**Field Modification Form  
Lower Passaic River Restoration Project  
Remedial Investigation  
Project No: 60145884**

<b>Field Modification Number: FM-131010-1</b>	
<b>Document (plan or SOP title and date)</b>	
Lower Passaic River Study Area, Low Resolution Coring Supplemental Sampling Program Addendum, Second Supplemental Sampling Program (SSP2) – Quality Assurance Project Plan (QAPP). Revision 1, September 2013.	
<b>Activity:</b> Locations for collection of sediment cores and grab samples in Third River.	
<p><b>Proposed Modification:</b> SSP2 QAPP included the collection of sediment cores and grab samples in Third River following the performance of a probing study in the Third River. The probing study was conducted on September 25, 2013. The results of this probing study (probe coordinates, water depth, sediment penetration, and nature of sediments) are presented in Table 1. The probe locations and sediment thickness are shown on Figure 1.</p> <p>Based on the results of the probing survey three core and grab sample stations are proposed to be added to the SSP2 sampling program. These stations fill in a spatial data gap longitudinally between LRC cores 2008 CLRC-109 and 2008 CLRC

Figure 1  
Third River SSP2 Sample Locations  
RM 10.5 to 13.9

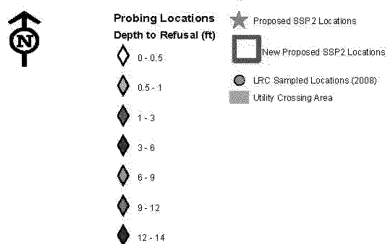
<b>Effective Date:</b> October 10, 2013	
<p><b>Rationale:</b> The SSP 2 QAPP anticipated the addition of stations in the Third River following the performance of the probing survey. This field modification form documents the addition of the three proposed stations.</p> <p>The attached figure shows the proposed three new stations in Third River.</p>	
<b>Submitted by:</b> Doug Simmons	<b>Date:</b> October 10, 2013
<b>FTM Manager Approval:</b> 	<b>Date:</b> October 10, 2013
<b>Project QA Manager Approval:</b> 	<b>Date:</b> October 10, 2013
<b>Task Manager Approval:</b> 	<b>Date:</b> October 10, 2013

Station Location			Siting Rationale				NAD <sup>4</sup> 83 NJ State Plane Feet	
Station ID	Approximate Sediment Elevation <sup>1</sup> NGVD29 Feet	River Mile	CPG Location (DQO 2)	USEPA Location (DQO 1)	Core and Grab	Grab	Easting	Northing
13B-0575		Third River		X	X		594473.26	723982.81
13B-0576		Third River		X	X		594380.29	724152.43
13B-0577		Third River		X	X		594316.95	594316.95
